**THE PINNACLE AT WILDHORSE RANCH**  
 CITY OF AUSTIN  
 TRAVIS COUNTY, TEXAS

CITY OF AUSTIN –DEVELOPMENT SERVICES DEPARTMENT  
SUBDIVISION APPLICATION – MASTER COMMENT REPORT

**CASE NUMBER:** C8-2021-0152  
**UPDATE:** U2  
**CASE MANAGER:** Juan Enriquez, Senior Planner [juan.enriquez@austintexas.gov](mailto:juan.enriquez@austintexas.gov)

**PROJECT NAME:** Pinnacle at Wildhorse Ranch  
**LOCATION:** 12000 BLUE BLUFF RD

**PRELIMINARY PLAN**

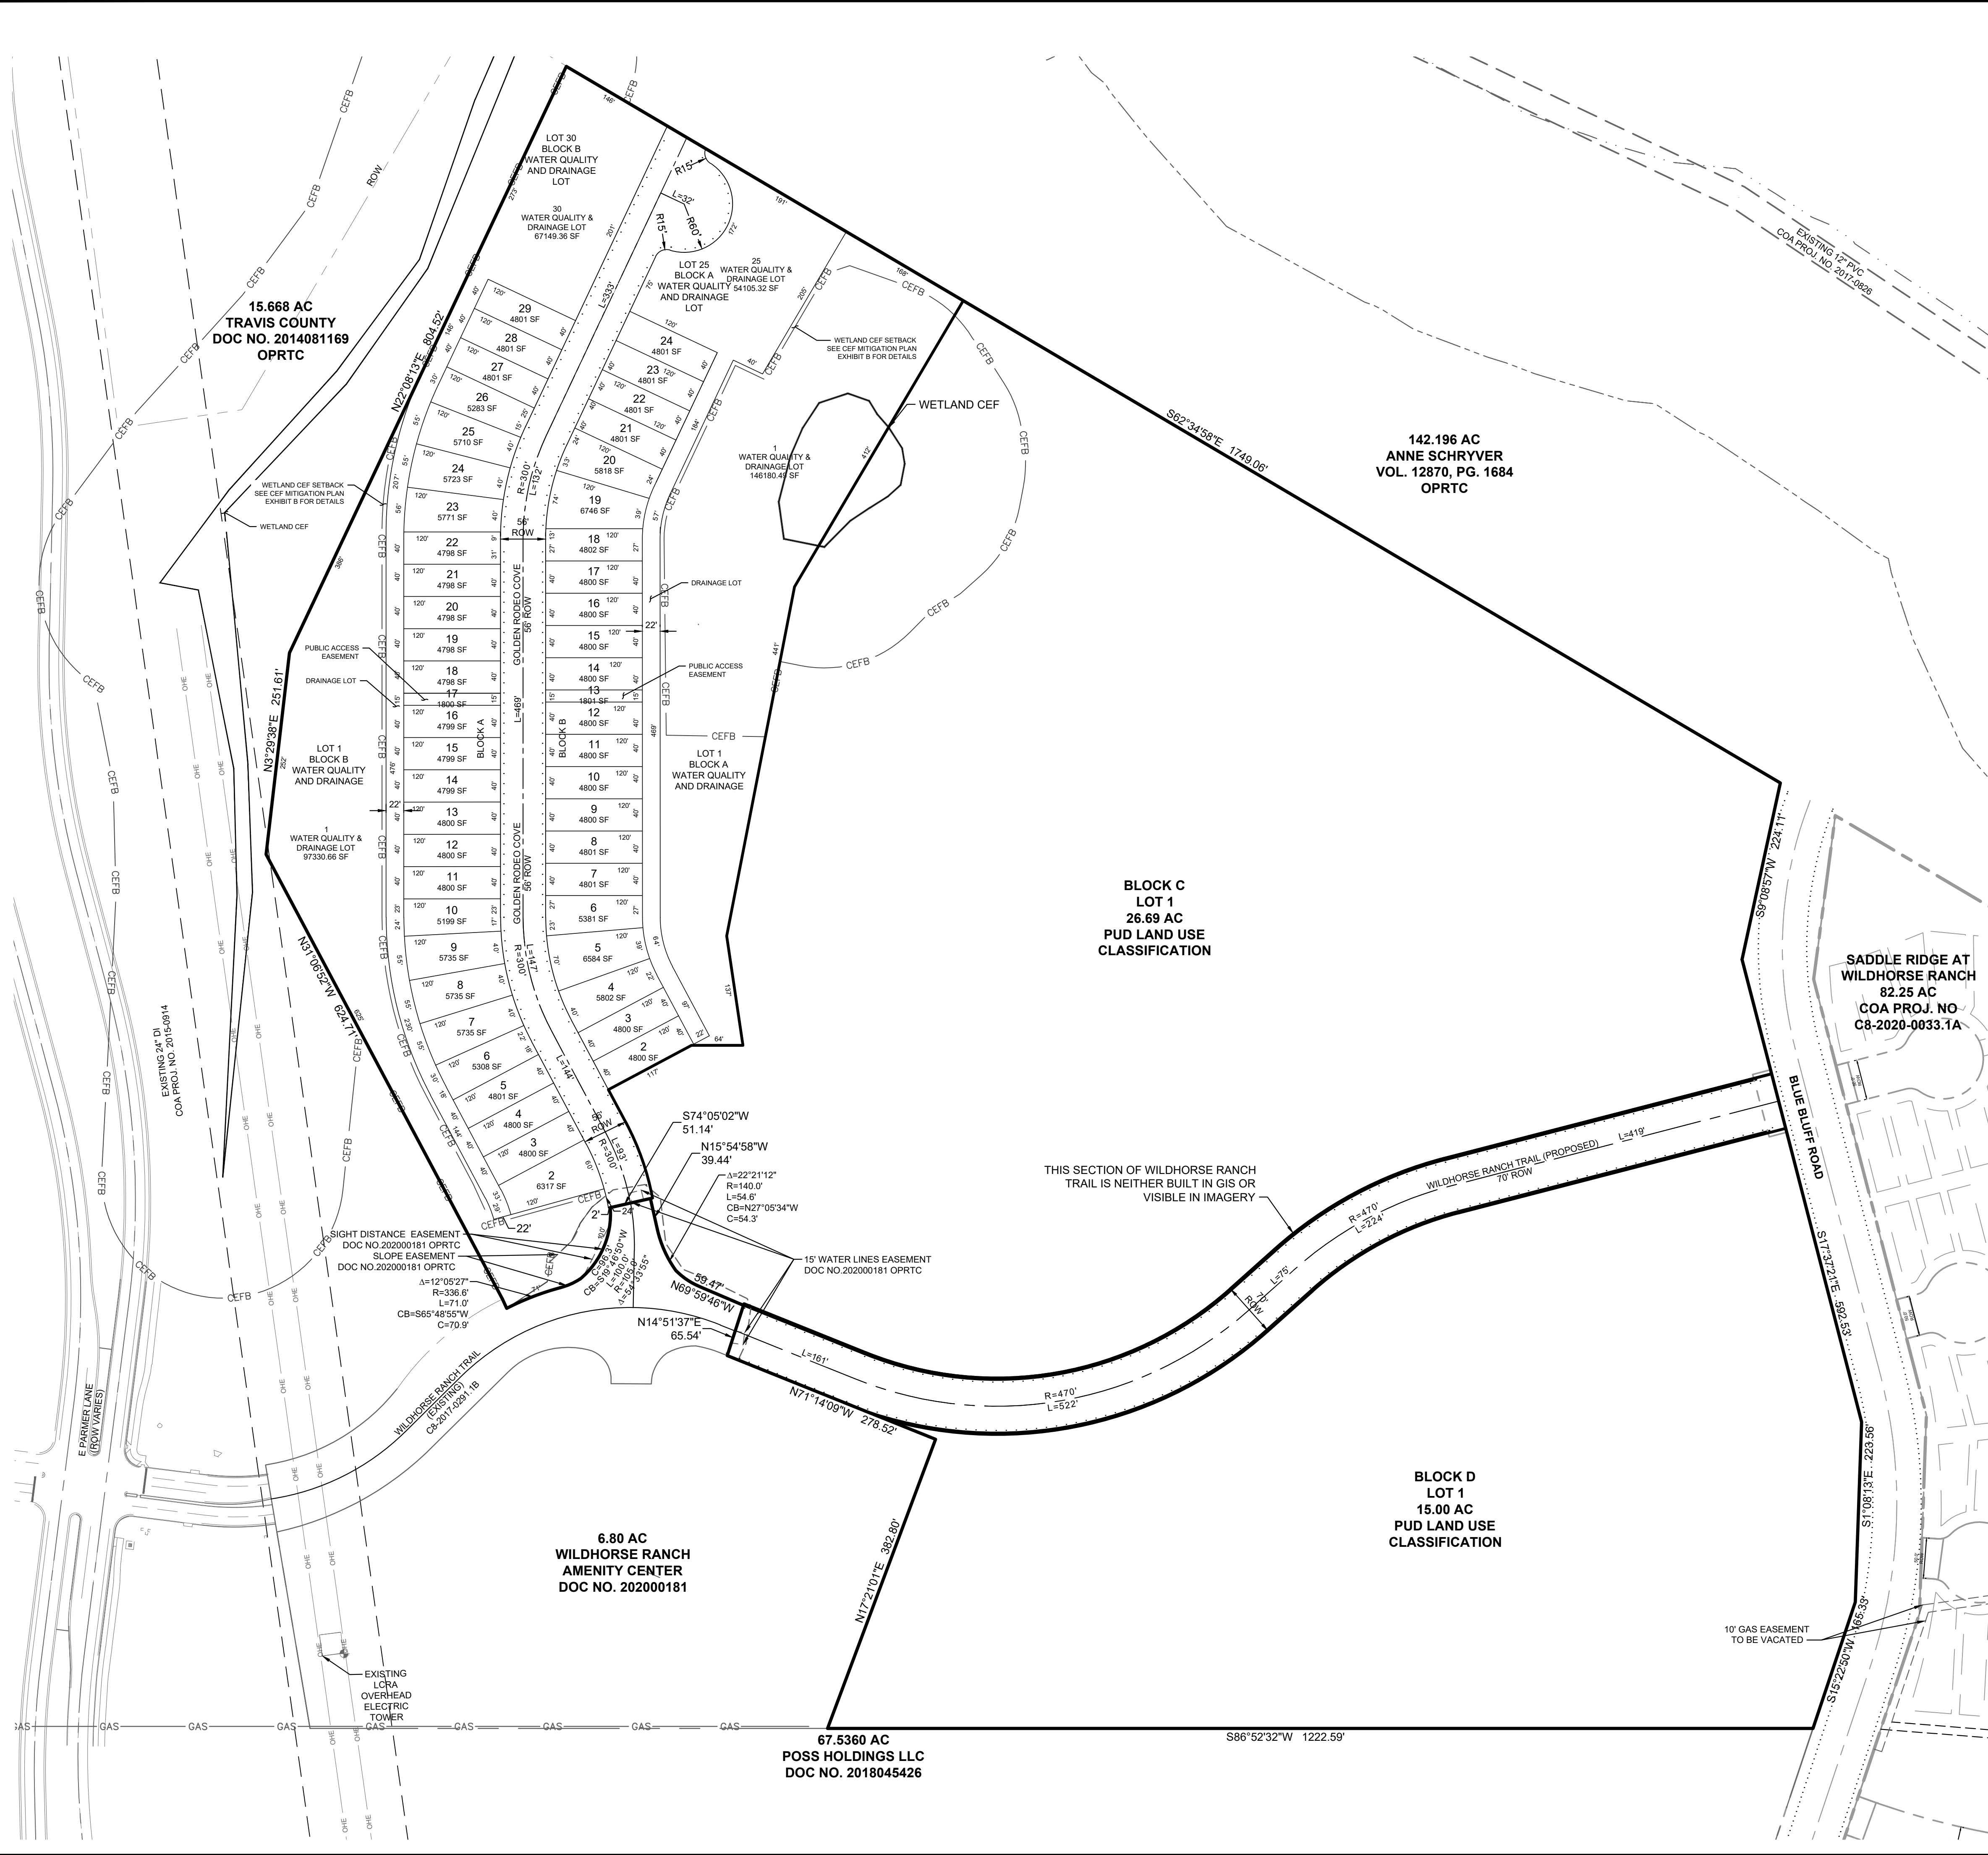
- ATD 2. Revise “sidewalk location” in the street table to just “sidewalk” and put the required widths in the column, according to street classification (4’ and 5’). Remove “back of curb”. TCM, Sec. 1.3.0.

ATD 5. Sidewalks are required on the subdivision side of BLUE BLUFF ROAD. Identify the location of the sidewalks by a dotted line on the preliminary plan. LDC 25-6-351. TCM, 4.2.1.

ATD 6. Add subdivision construction case number (C8-2017-0291.1B) to the WILDHORSE RANCH TRAIL (West of the roundabout).

U1: Comment remains. Please, change the location of the case number to the west of the roundabout. Previous comment had a typo.

**U2: Comment cleared.**

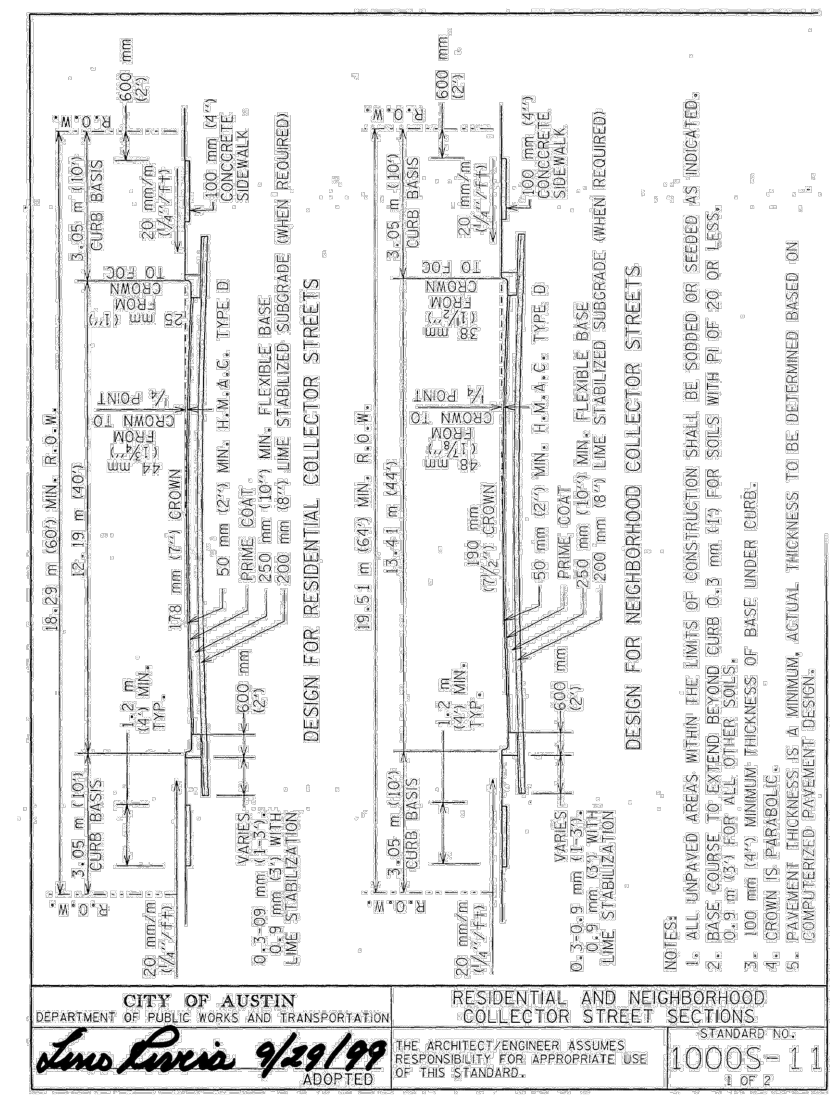
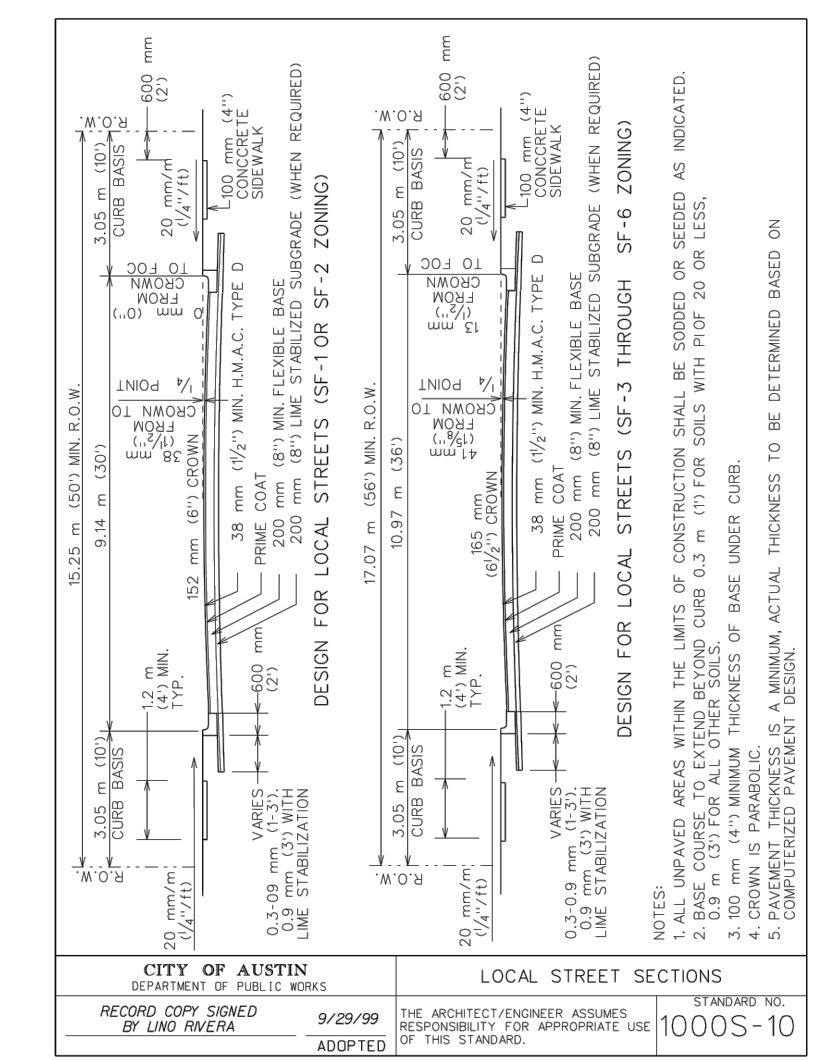
**WB3** Demonstrate that this project complies with Critical Environmental Feature protection requirements. [LDC 25-8-281 or LDC 30-5-281; LDC 25-8-282 or LDC 30-5-282; ECM 1.10] *{Additional information: {This reviewer cannot determine wetland CEF protection provisions and potential wetland CEF 1:1 mitigation. Please provide more detail on the "Exhibit B – CEF MITIGATION SHEET"}*

- a. *This sheet should encompass all proposed wetland CEF setback mitigation including a balance table specifying the total acreage of proposed wetland CEF/CEF setback area encroached upon/impacted/reduced as well as the total acreage for each of the proposed mitigation methods.*
- b. *Please provide all details for planting and seeding meeting the minimum criteria of 609S to include the seed specification (species, total pounds, etc.) and the tree/shrub specifications (species, quantity, size, and location).*

Update 1 Rename the planting tables "Wetland Mitigation" instead of "Floodplain Modification." Provide planting tables for areas indicated for wetland restoration and biofiltration planting area with appropriate species/quantities. The upland planting area tables do not seem to match the acreage indicated in the exhibit plan. Provide more detail about the acreage proposed to be planted.

**Update 2. Comment cleared. FYI, wetland CEF mitigation will be finalized at either site plan or subdivision construction plan. It is still unclear what areas are being planted and whether the areas indicated as "PLANTING AREAS ADDED" are included in that calculation.**
